## ADDENDUM No. 3

### RFP No. 22-76

#### East Medical Center Drive Bridge Rehabilitation and Widening Project

PROJECT MANAGEMENT - PUBLIC SERVICES - CITY OF ANN ARBOR	
<b>EAST MEDICAL CENTER DRIVE</b>	SCALE HOR. 3/32"=1'-0"
<b>STRUCTURAL STEEL DETAILS</b>	DRAWING NO. <b>2021-008-BR36</b>
<b>BOLTED BEAM END REPAIRS</b>	SHEET NO. <u>99</u> OF <u>153</u>

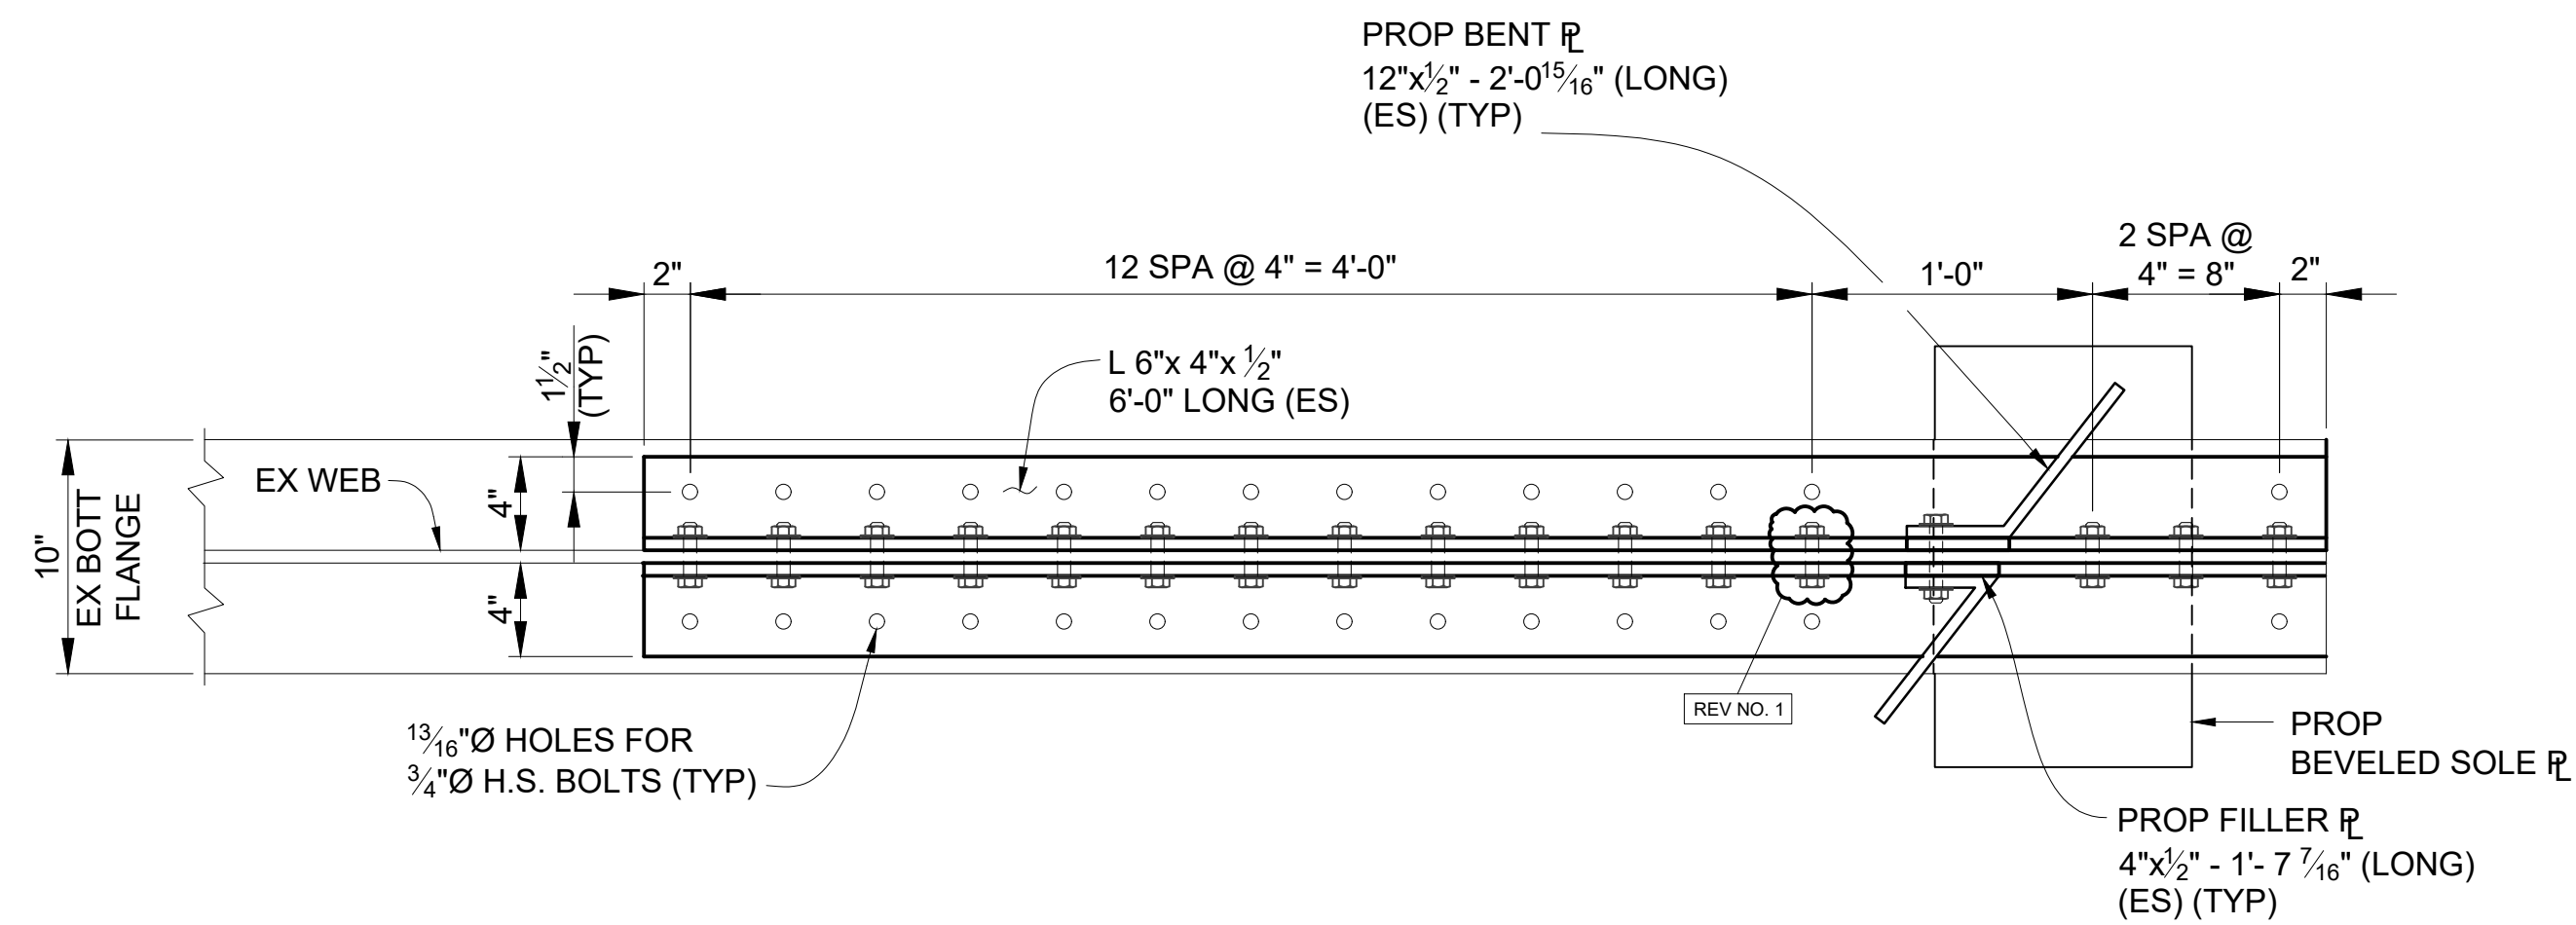
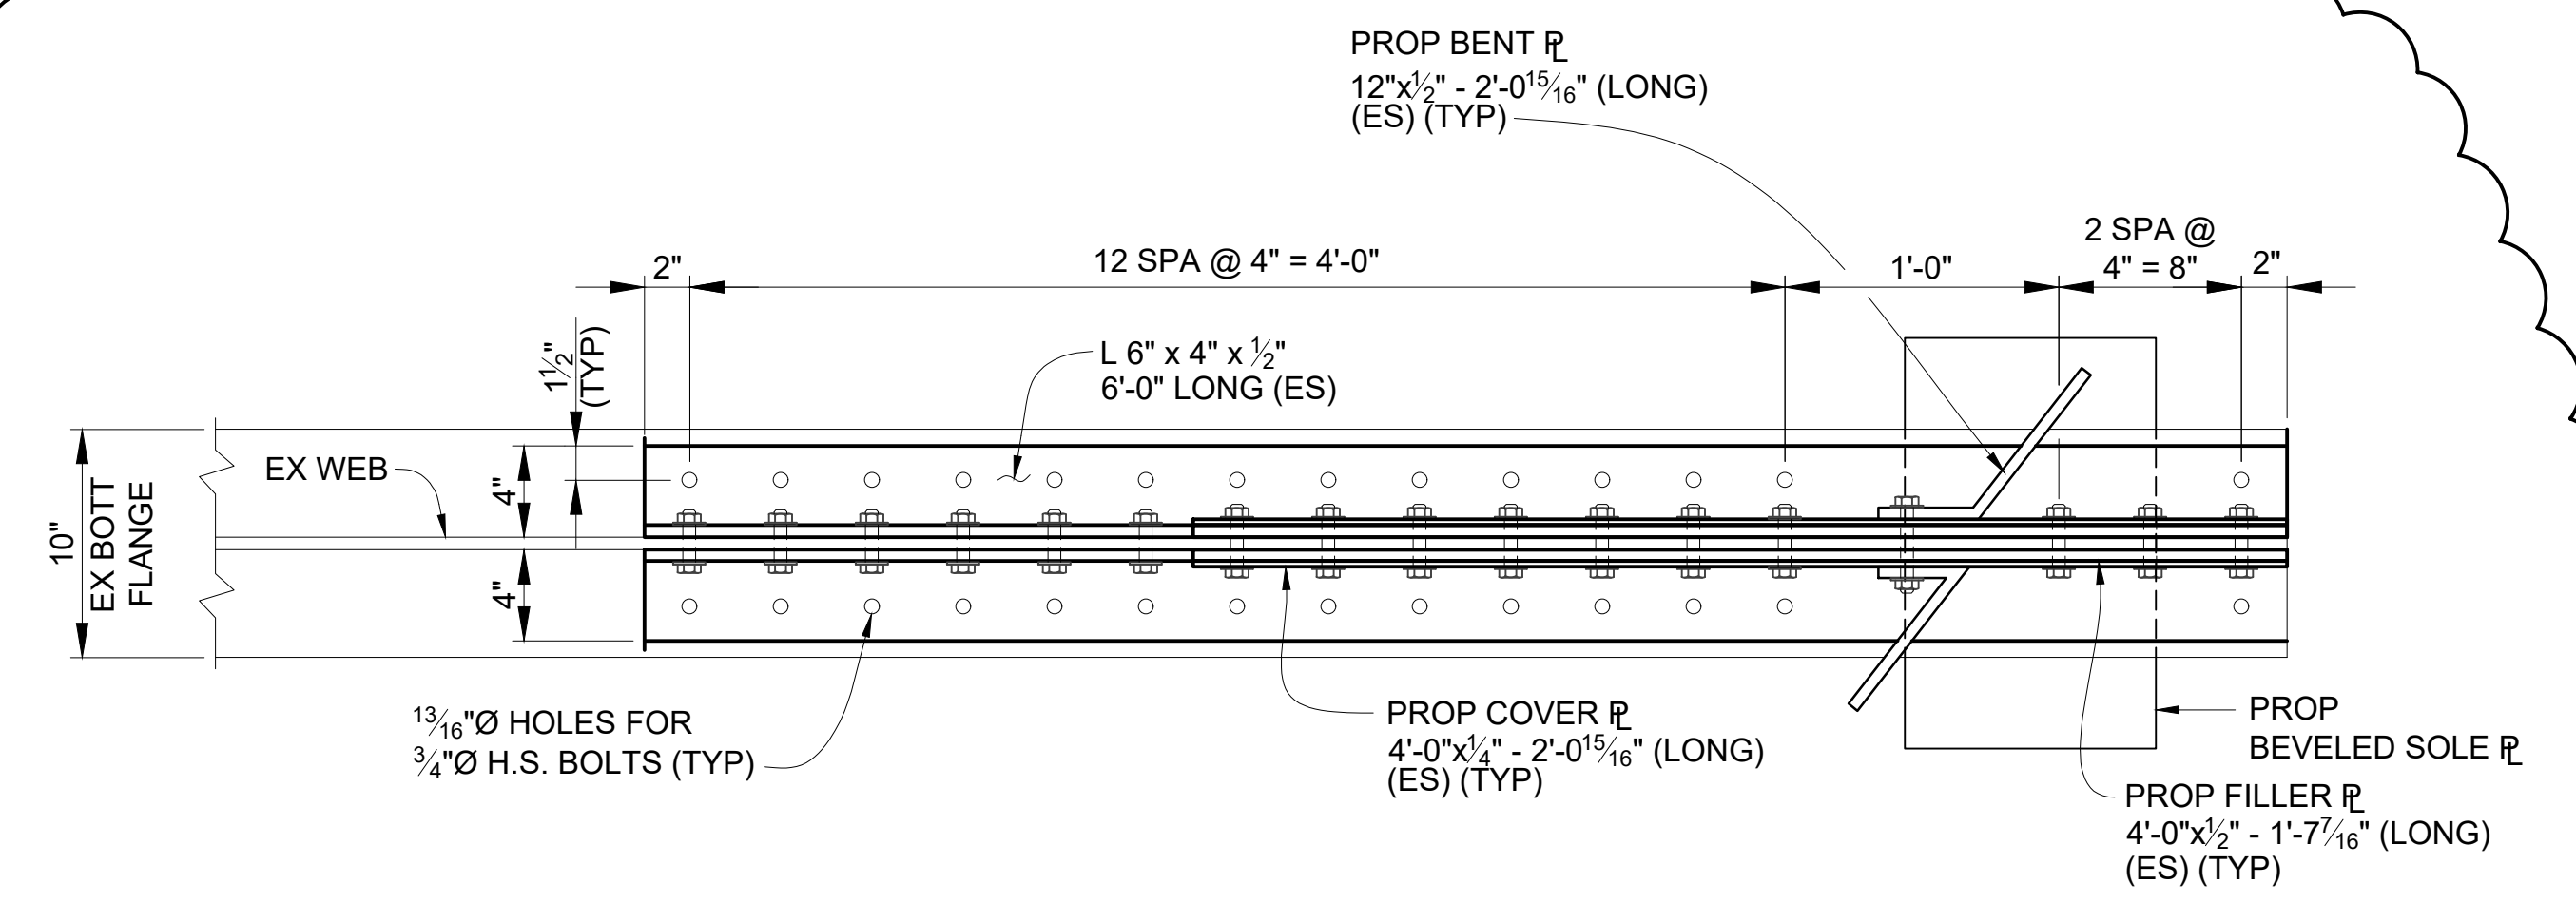
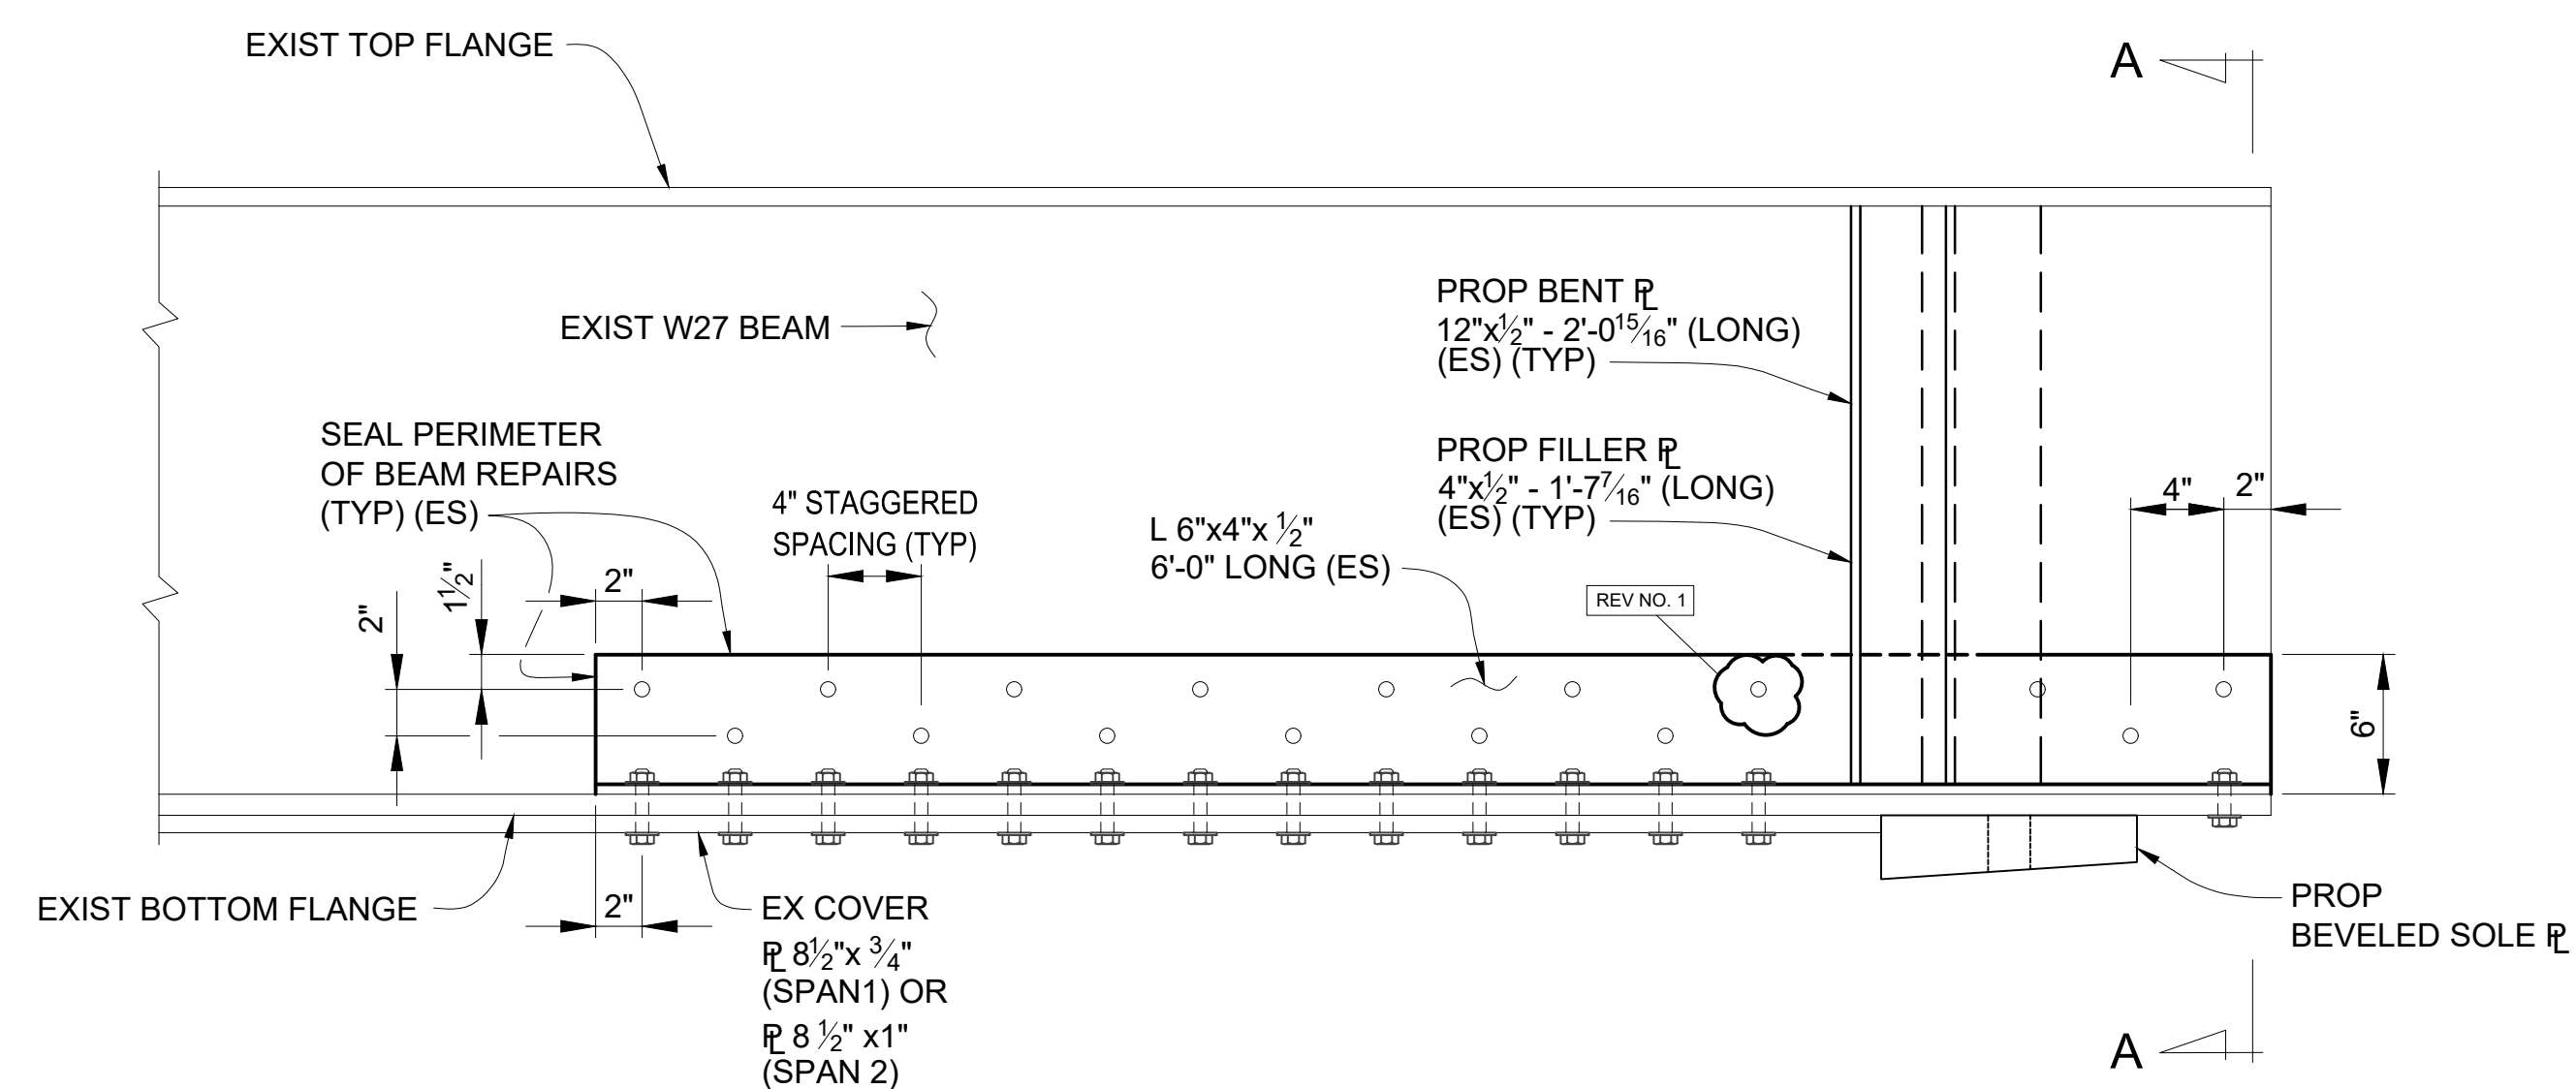
RFP_22-76_Plans Sheet 99	The bolted repair details have been updated based on the results of the October 2022 bridge inspection.
RFP_22-76_Plans Sheet 104	Barrier post spacings in the Span 1, west sidewalk were shifted to make room for chain link fence posts around the light standard.
RFP_22-76_Plans Sheet 105	The cross-sections were updated to show a proposed chain link fence on top of the barrier.
RFP_22-76_Plans Sheet 106	The cross-section was updated to show a proposed chain link fence on top of the barrier.
RFP_22-76_Plans Sheet 109	The splashboard panel spacing was replaced with chain link fence post spacing.
RFP_22-76_Plans Sheet 110	The splashboard panels are being deleted from the plans.
RFP_22-76_Plans Sheet 111	<p>A note was added to the plans to provide direction for the proposed fencing.</p> <p>A pay item for "Elec Grounding System" with a quantity of 1 Ea was added to the plan sheet.</p> <p>A pay item for "Fence, Structure" with a quantity of 2,635 Sft was added to the plan sheet.</p>
